**Assessment of Ten (10) Protected-Size Trees
at
55 Rogers Road
Los Gatos, California**

Prepared for:
Mr. Levi Hill, Associate Planner
Town of Los Gatos Community Development Department
110 E. Main Street
Los Gatos, CA 95030

Report by CTA
Version: 12/6/2016

3.0 Tree Location & Protection Fence Map

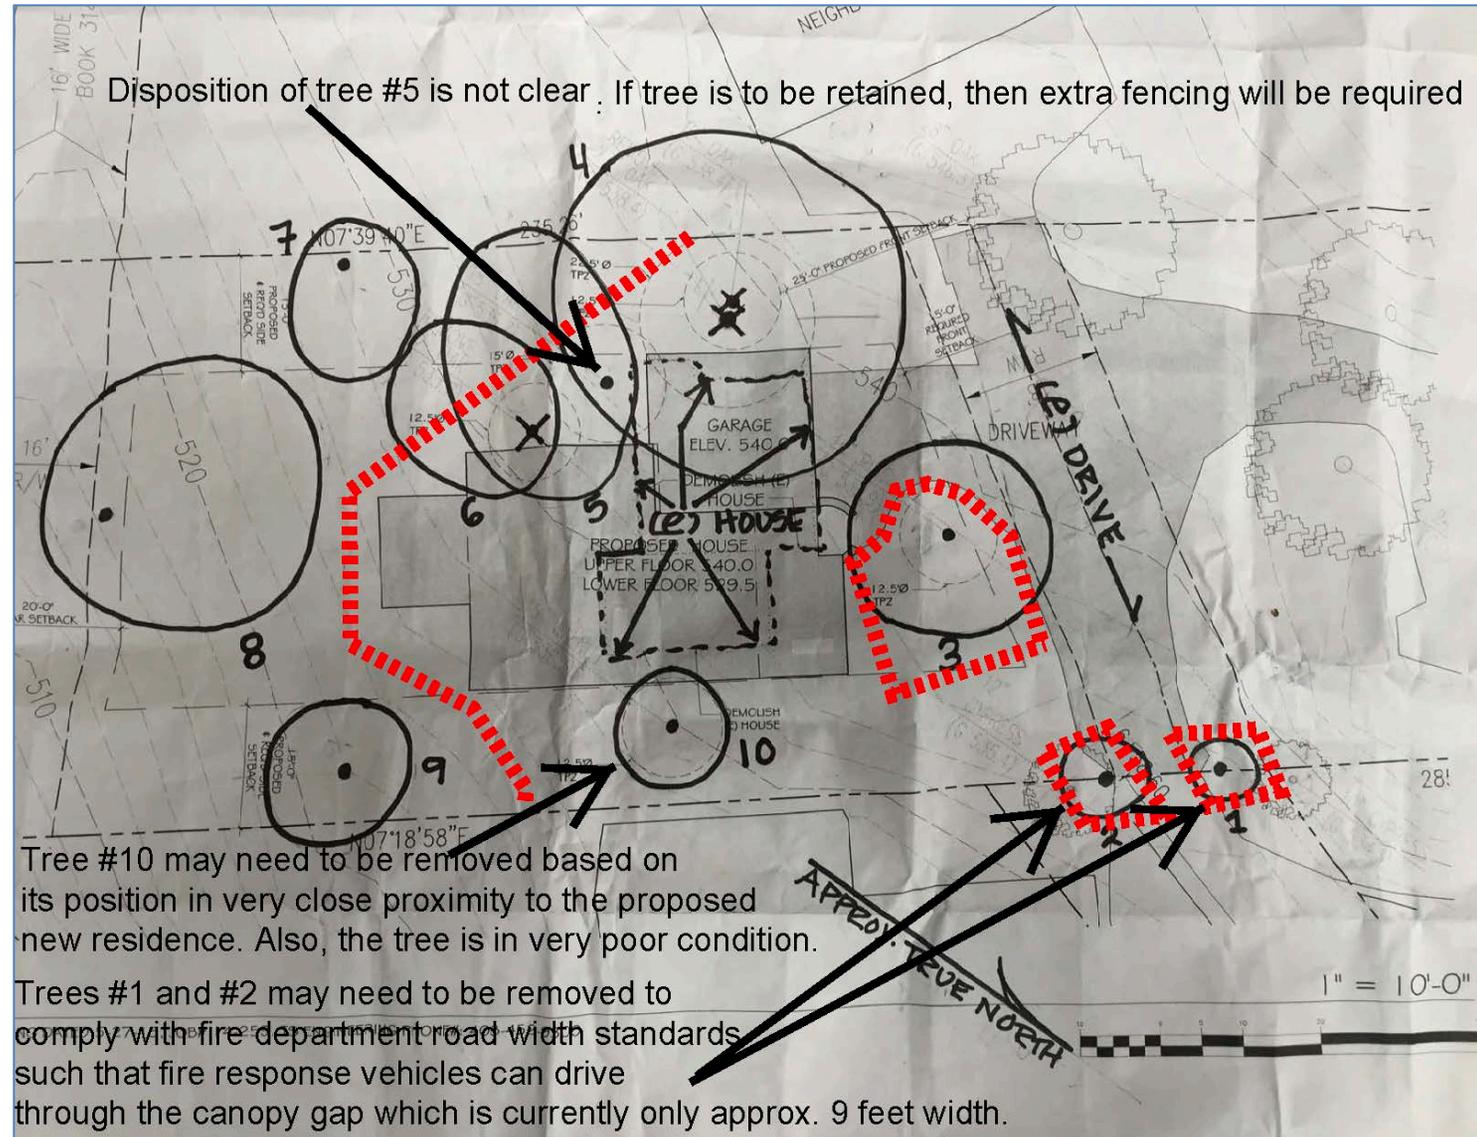
The CTA marked up the applicant’s preliminary proposed site plan sheet A1 drawn 10/4/2016 by Chris Spaulding, Architect, of Berkeley, California which is rendered over a topographic survey by TS Civil of Los Gatos, California.

Tree canopy edges or “driplines” are shown to approximate scale using black outline clouding on this marked-up sheet for all ten subject trees. Disregard the architect’s CAD renderings of the canopy driplines which are shown far too small in diameter compared to actual.

Note the existing residence dimensions as shown on this sheet as black dashed line, along with the proposed new residence footprint shown shaded.

The CTA's initial suggested routes for chain link tree root zone protection fencing are noted as red dashed lines. The current suggested fence route for trees #1 and #2 is probably not feasible, since the driveway area needs to be kept open for fire trucks to certain code distances. The CTA suspects that trees #1 and #2 may need to be removed in order to achieve the minimum fire truck width distance (not verified at time of writing). The disposition of trees #5 and #10 is also open to debate. It is expected that one or both of these trees will also need to be removed due to their close proximity to the proposed residence footprint.

Trees #7, 8, and #9 can be retained without significant impacts, assuming that chain link fencing is erected at the locations specified on the CTA's tree map in this report.

Pre-demolition fence: Per the red dashed lines on the tree map mark-up in the CTA's arborist report (routes may be subject to change, depending on the finalized alignments of work items).

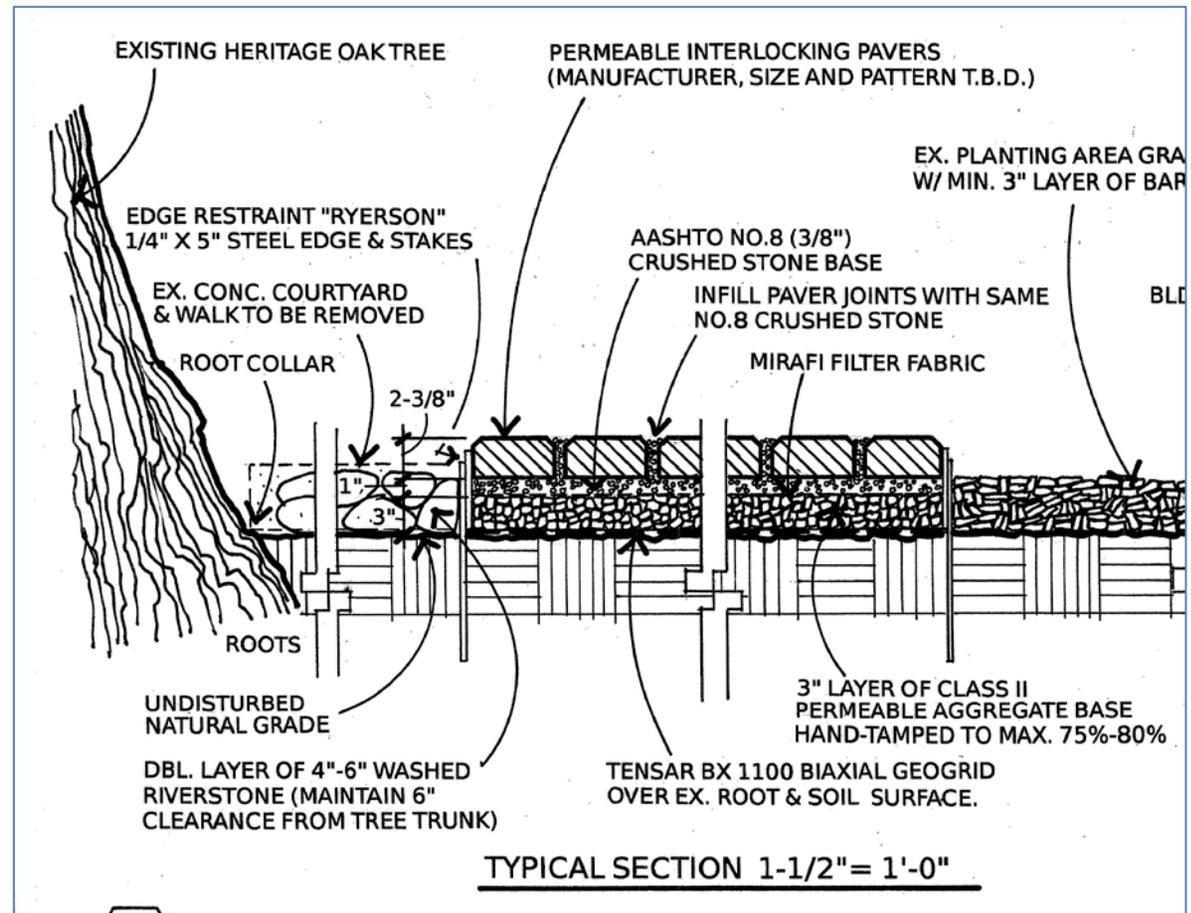
ii. Driveway Grades & Footprint: Project team shall verify driveway elevations. If the proposed new cut elevations are below existing elevations, then the project team shall consider moving the driveway footprint southwestward to achieve better offset distance between the trunk edge of pine #3 and the driveway edge.

iii. Driveway Option / No-Dig: If the driveway can be built over existing grades without cutting down into the root system of pine #3, then project team shall consider use of a biaxial geogrid such as Tensor BX-1100 as an underlayment over existing soil base. This is called a no-dig or floating driveway system (see sample spec side cut detail at right). This system allows for 100% retention of lateral tree roots, with no cuts at all into the ground, other than steel pins that are placed to hold the over-grade steel Ryerson edging restraints.
